RE: Drainage Complaint for 440 Narcissus Place SE (L23-D1C))

RE: Grading Plan for 440 Narcissus Place SE (L23-D1C)) Dated January 30, 2002

RE: Grading Plan for 440 Narcissus Place SE (L23-D1C)) Dated January 30, 2002

DRAINAGE INFORMATION SHEET

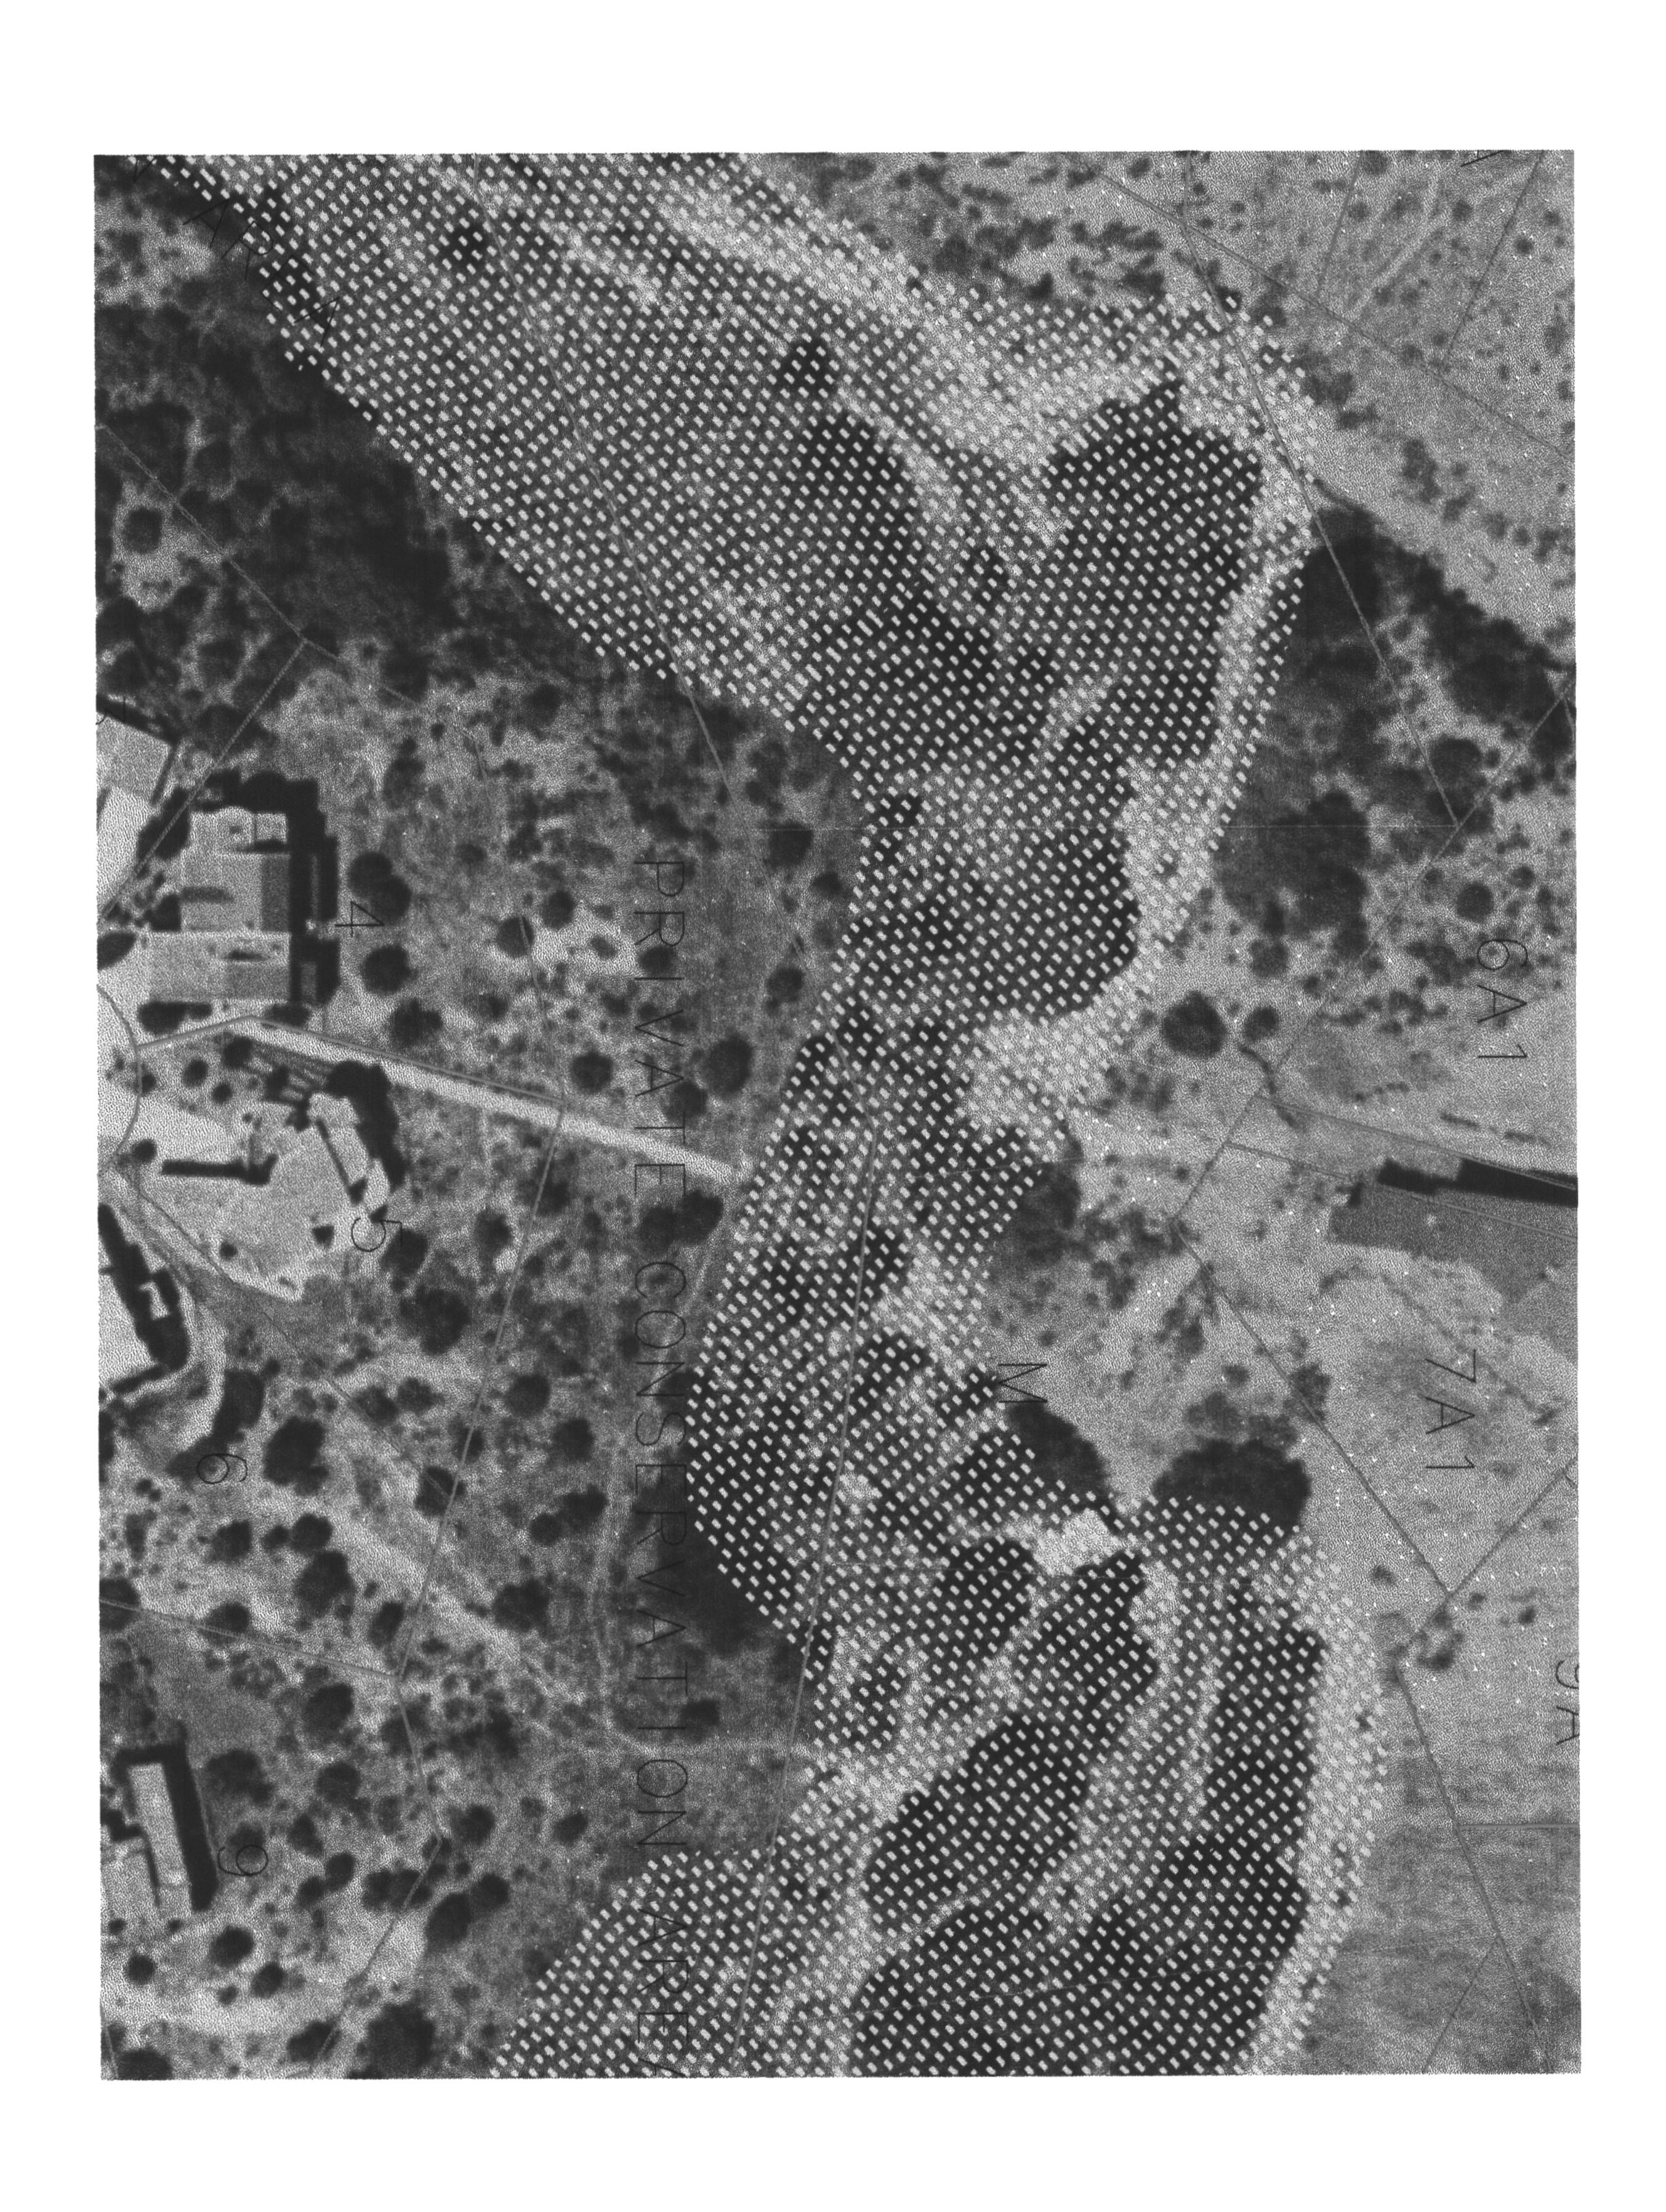
- 1. I have attached a Real Property Encroachment Agreement form for your review. Because you are constructing retaining walls over the Tijeras Interceptor Sanitary Sewer Easement you will need to process this encroachment agreement. I spoke with Roger Green, Development and Building Services, who can give you more information on the matter (924-3989).

- 2. It appears that you are grading and building the retaining wall outside of your lot of 440 Narcissus Place. Please submit a legal description for the lot you are making improvements on. Is Masha the owner of this lot? Please show on the drawing the deeded lot.

- 3. The grading and retaining wall is being placed on is on a deeded lot. The drawing indicates that this is an open space area that has restrictions. Please submit the latest plat for this area. Are there any restrictions on grading and the construction of retaining walls?

- 4. I spoke with the Planning Department on the SU-1 zoning. They indicated that there was not a problem with what you were doing as far as zoning.
- 5. The grading plan uses a sanitary sewer manhole as a benchmark. Please indicate if this is an accurate benchmark and has been checked.

6. Please be aware that the City is going into construction soon in our easement. Future retaining wall construction should not interfere with the City's construction.
